70-2955

June 21, 1982

Reference: Docket No. 70-2955

Additional information requested  
per NRC letter on docket no. 70-2955

FLOOD INSURANCE RATE MAP

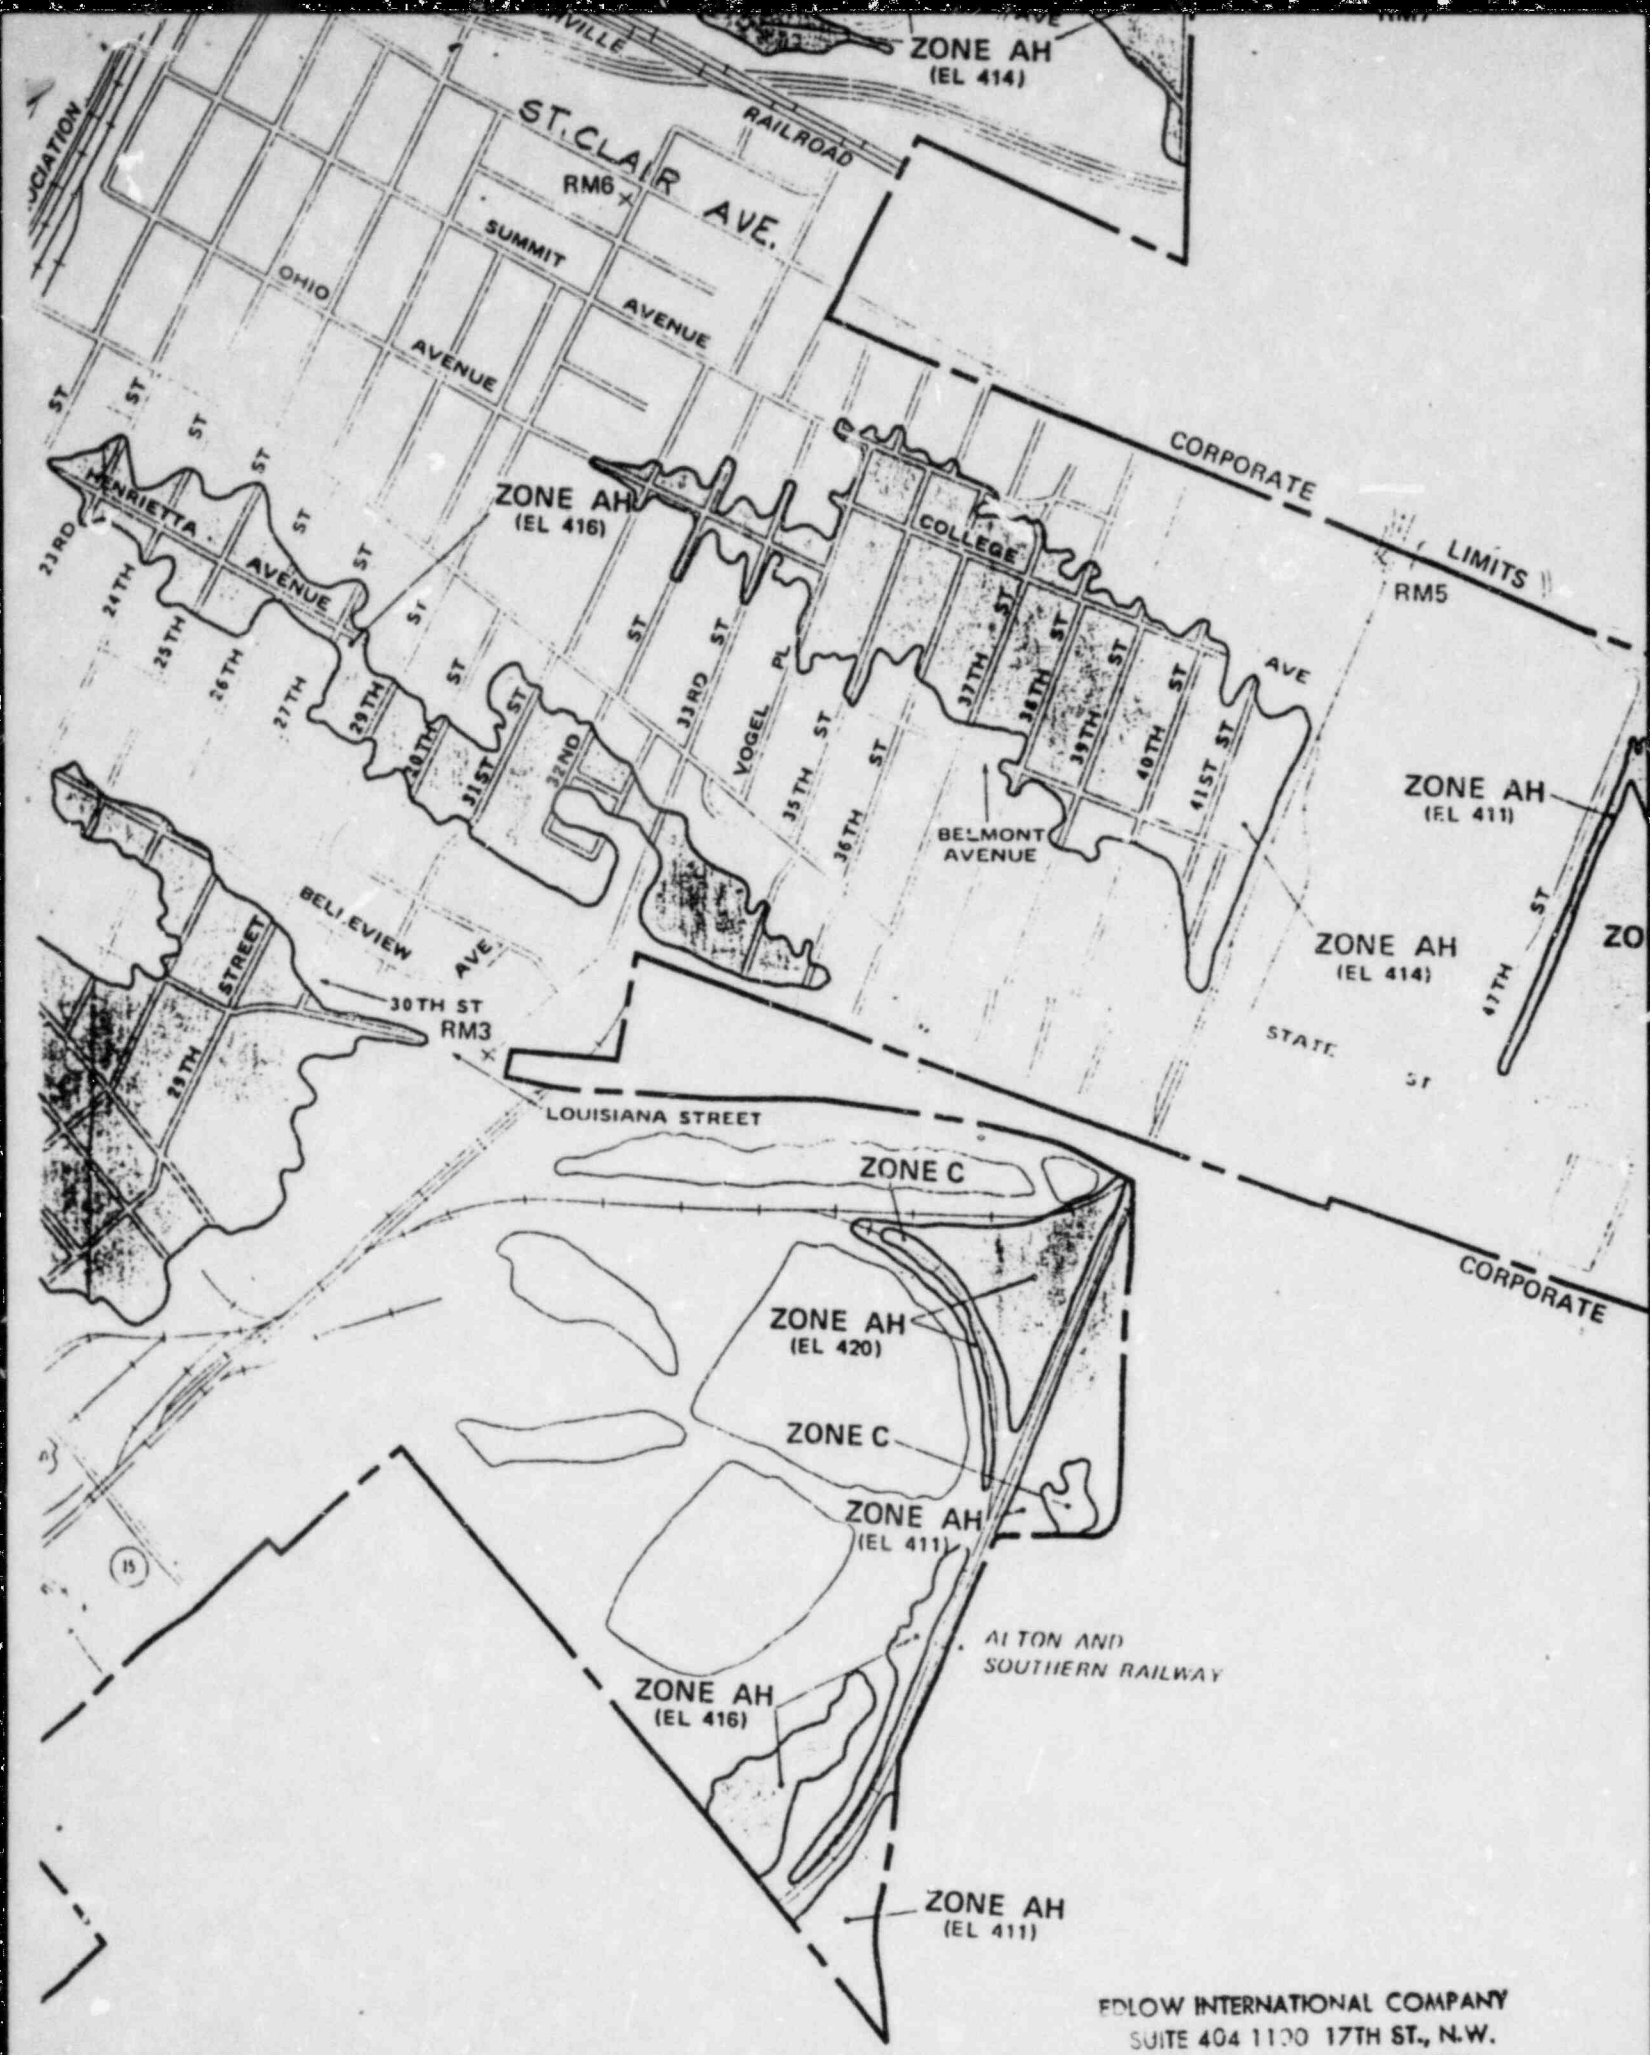
5. Concerning the possibility of flooding in the storage area, please find attached a letter with enclosure from the U.S. Corps of Engineers dated 13 January 1982. Based on this letter and attached map, and the fact that the warehouse floor is elevated approximately four feet above street level, the storage area will not be subject to flooding.

This site is not within a flood hazard and so indicated on the Federal Insurance Administration's map for the city of East St. Louis, Illinois (Incl 1).
